**FINAL DRAINAGE REPORT
FOR
STERLING RANCH RECYCLING FACILITY**

**November 2022
Project No. 25188.14
PCD Filing No: PPR-22-041**

**Prepared By:
JR Engineering, LLC
5475 Tech Center Drive, Suite 235
Colorado Springs, CO 80919
719-593-2593**

STERLING RANCH RECYCLING FACILITY PROPOSED DRAINAGE MAP

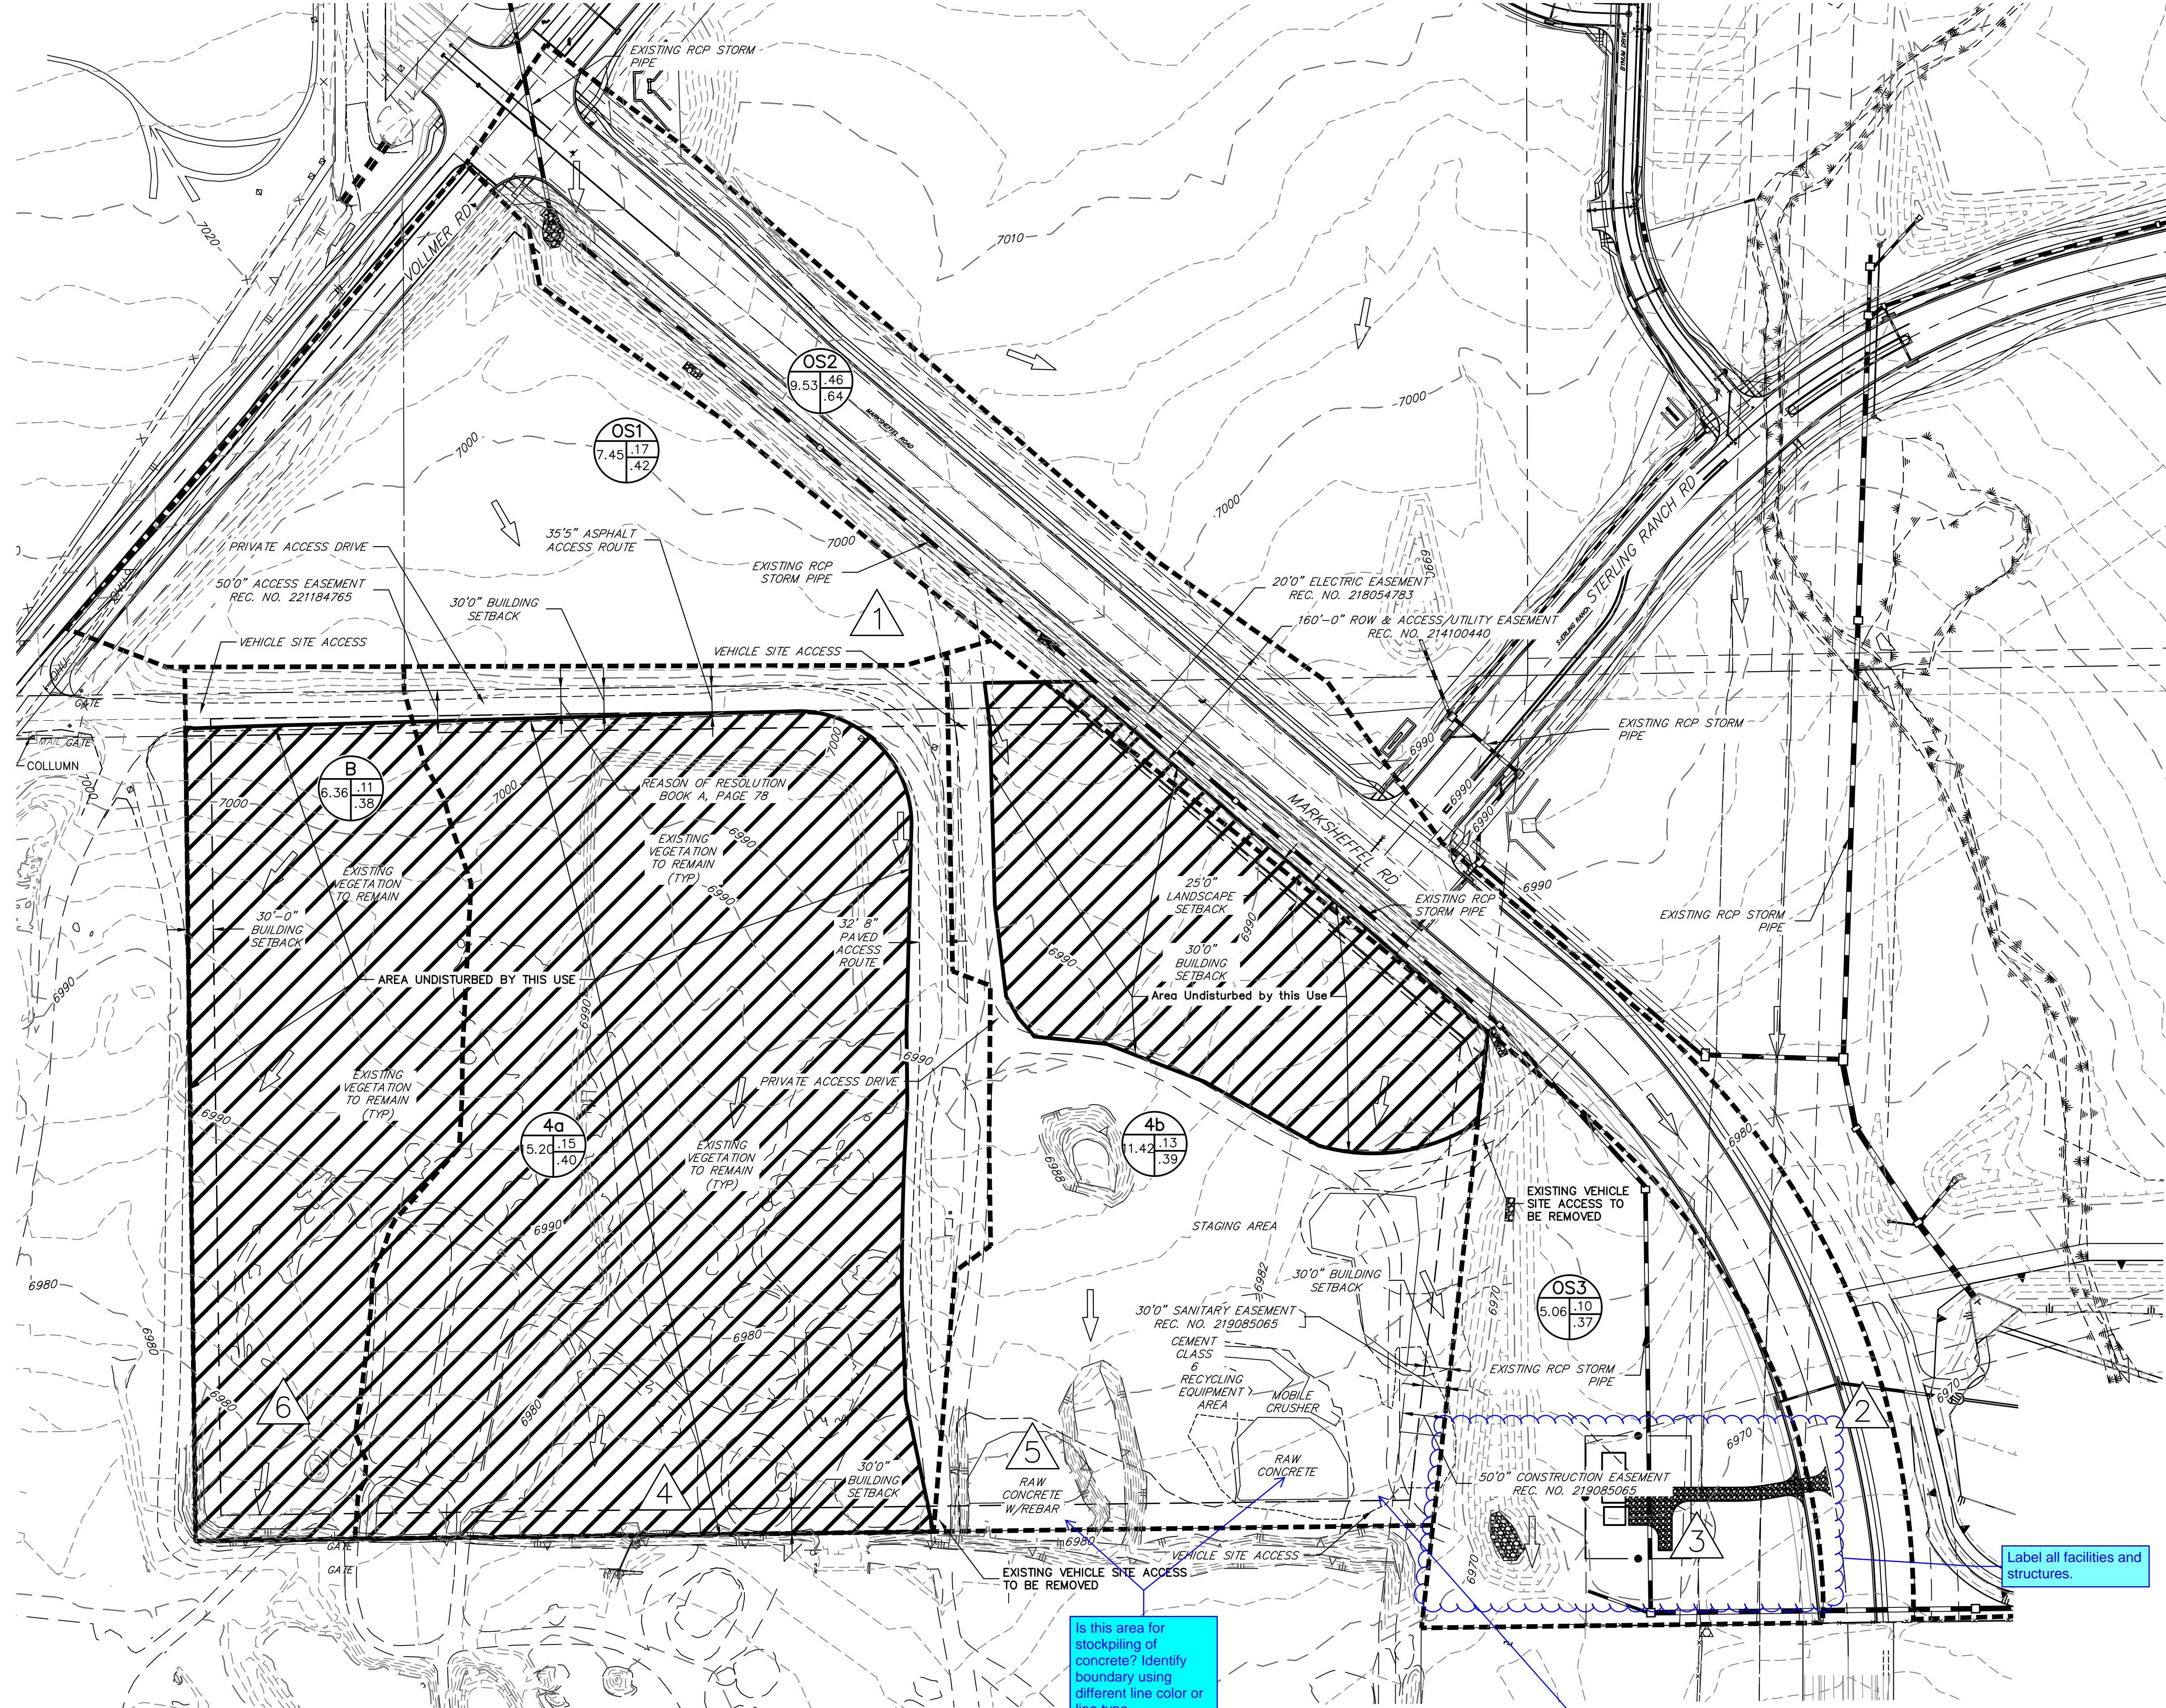
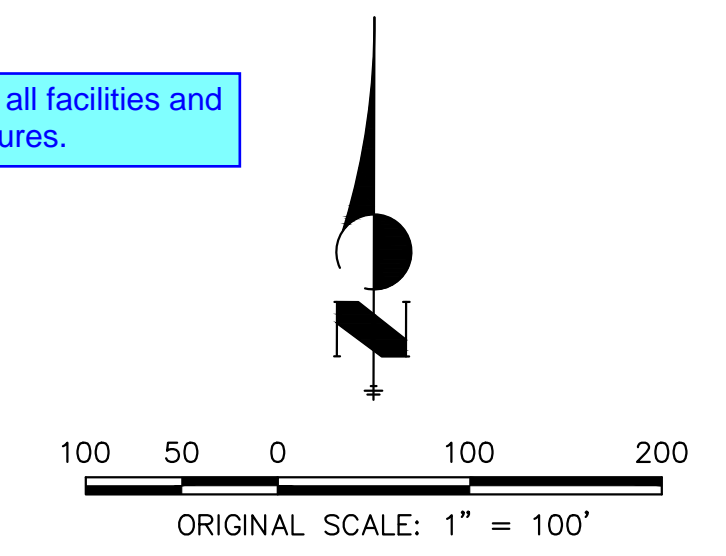
Clearly show where water quality facilities are provided or adequate conveyance to those facilities, and describe them (Pond W5 FSD?).

If runoff reduction is proposed, the stabilized vegetated area with easement needs to be identified.

Label all facilities and structures.
